TO:	Emily Wentworth, Town of Hingham	DATE:	March 30, 2016
FROM:	Joe SanClemente, P.E., AICP	HSH PROJECT NO.:	2015151.01
SUBJECT:	Avalon Hingham Shipyard II – 319 Lincoln Street Vanasse Traffic Peer Review – Response to Comments

Howard Stein Hudson (HSH) has prepared this memorandum in response to the comments received on the Avalon Hingham Shipyard II Project from the Town's peer review consultant, Vanasse & Associates, Inc. (VAI) in a memorandum dated March 10, 2016. Since that time the Proponent has reduced the scope of the Project to include just 190 residential units (60 fewer units) and associated adjustments to the site plan. HSH has prepared a technical memorandum documenting the change to the Proposed Project, the reduced traffic impacts, and the proposed mitigation.

Figure D.9. SU-40 Turning Movements Pulling in from Service Aisle/Fire Lane

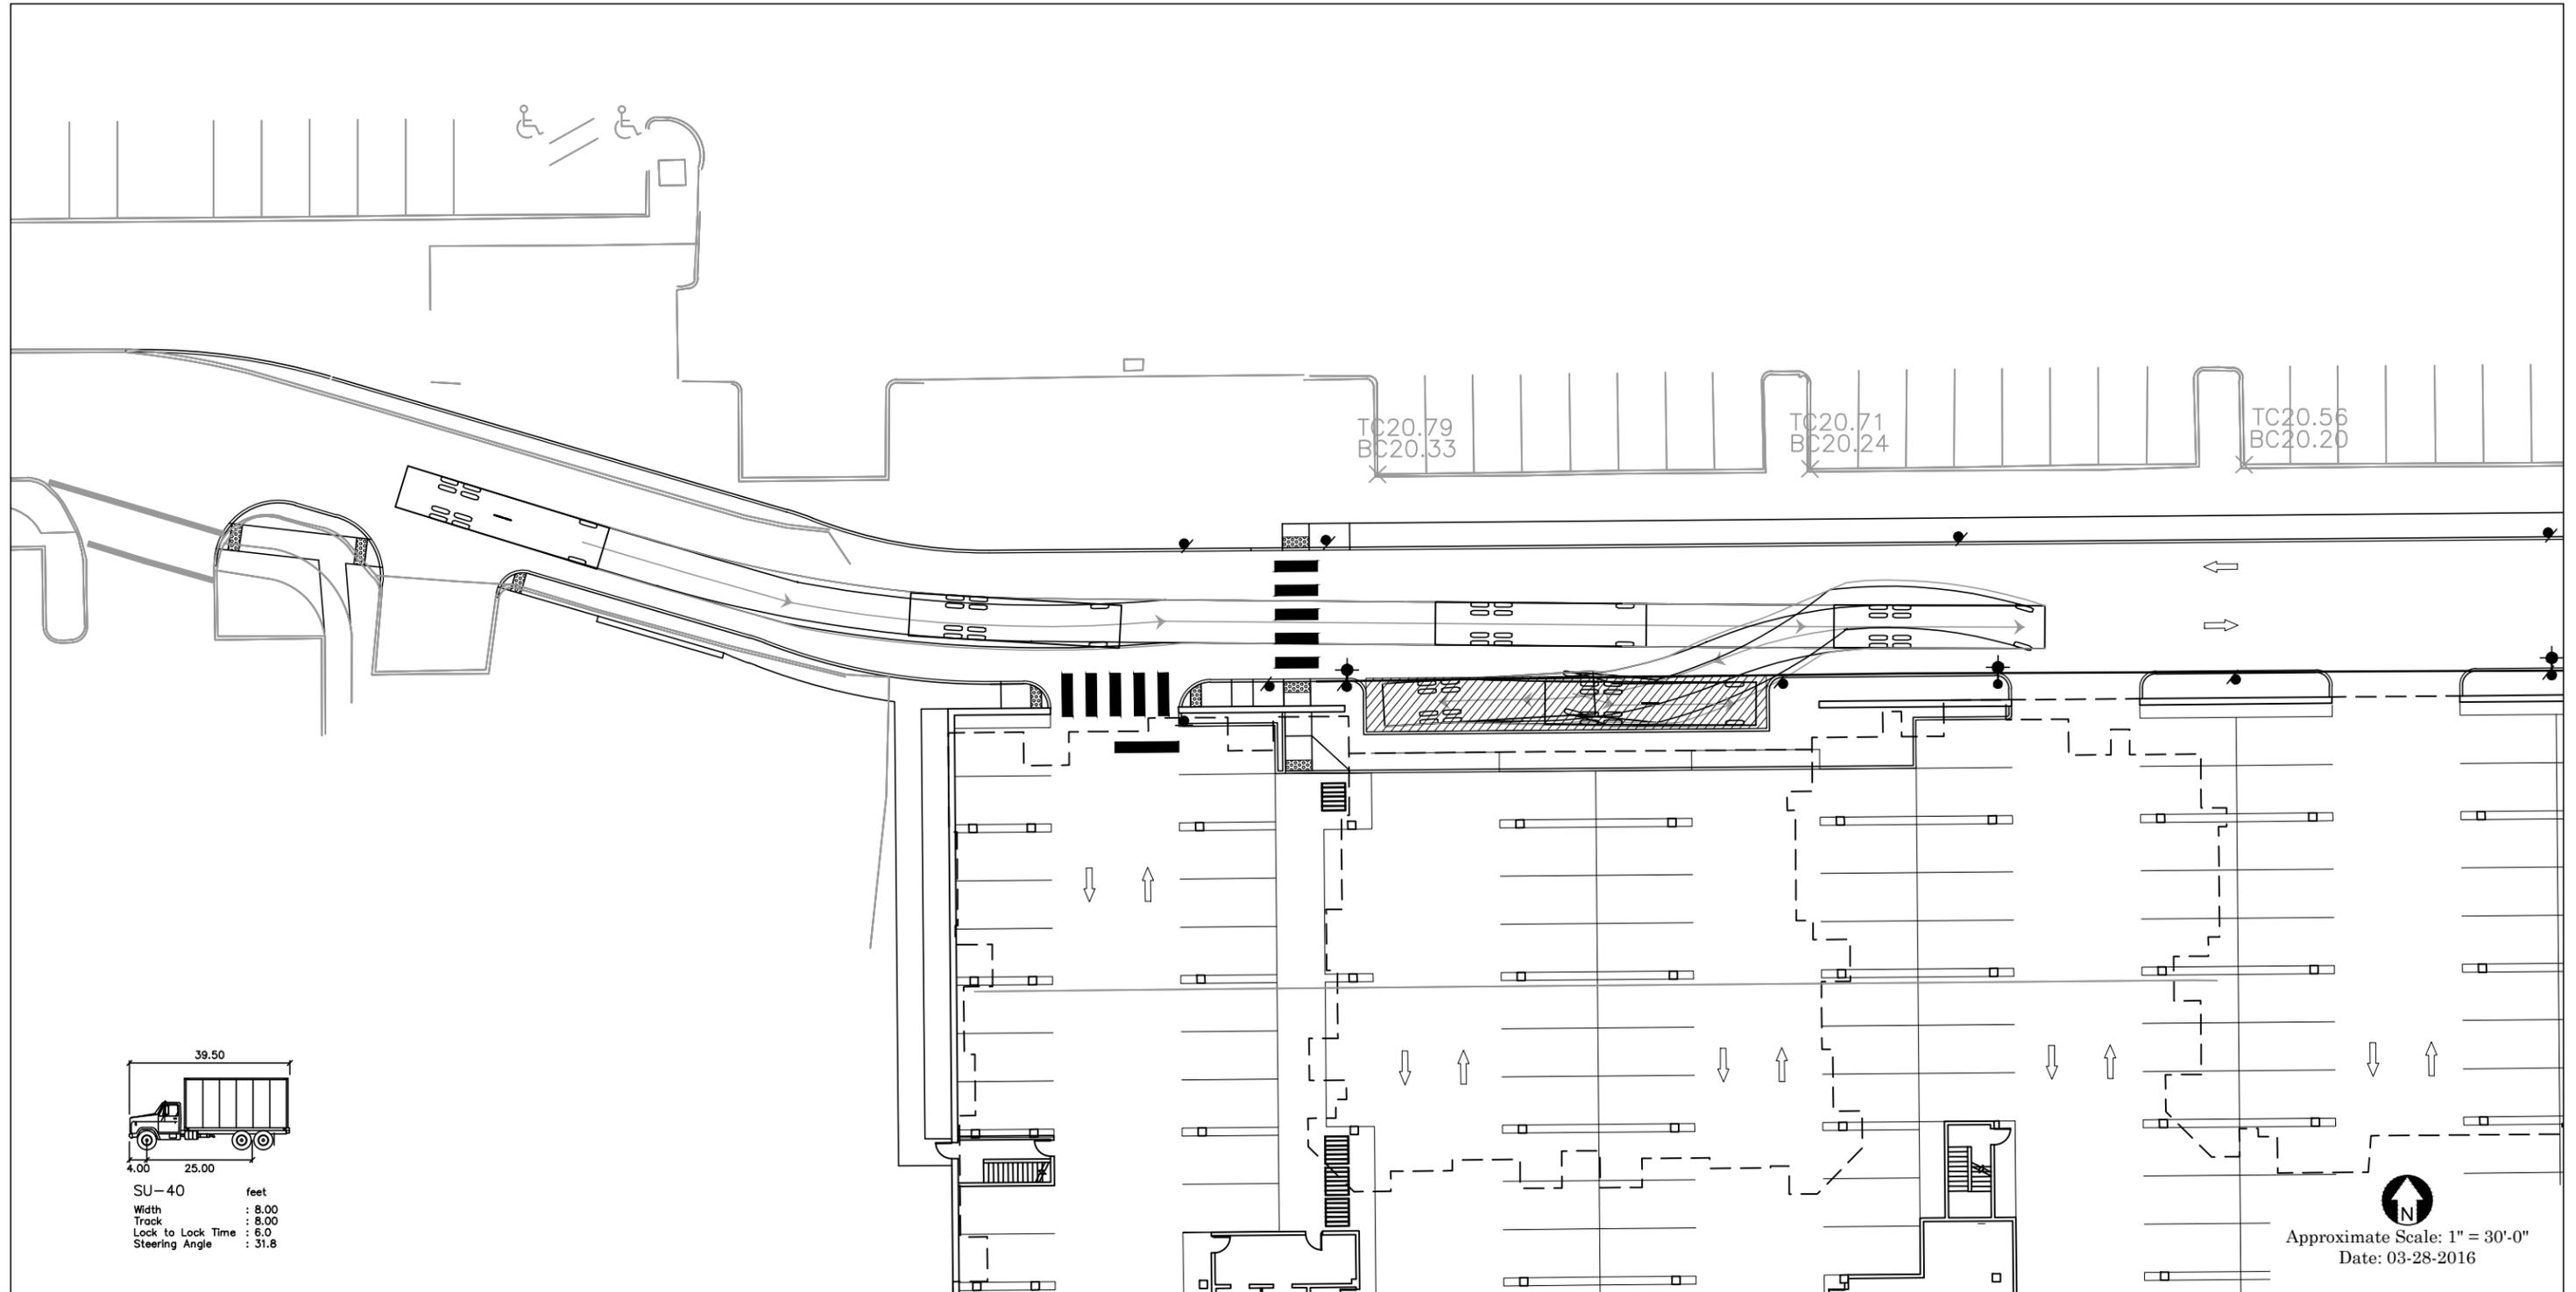
**Comment 1:** The Applicant's engineer provided a truck turning analysis for the Town of Hingham Fire Department design vehicle (tower truck) and an intermediate size tractor semi-trailer combination (WB-50). The turning analysis demonstrated that the subject vehicles can access and circulate within the Project site in an unimpeded manner; however, we note that the fire truck would need to back-up to exit the visitor parking area. The Applicant's engineer should also provide a turning analysis for an SU-30/40 (small delivery/moving vehicle and trash/recycling vehicle) that demonstrates that the subject vehicle can access and stage in the loading areas without blocking the garage access points. In addition, the analysis should also demonstrate the location and maneuvering required to serve the trash/recycling area.

Response 1: See attached truck turning analysis.
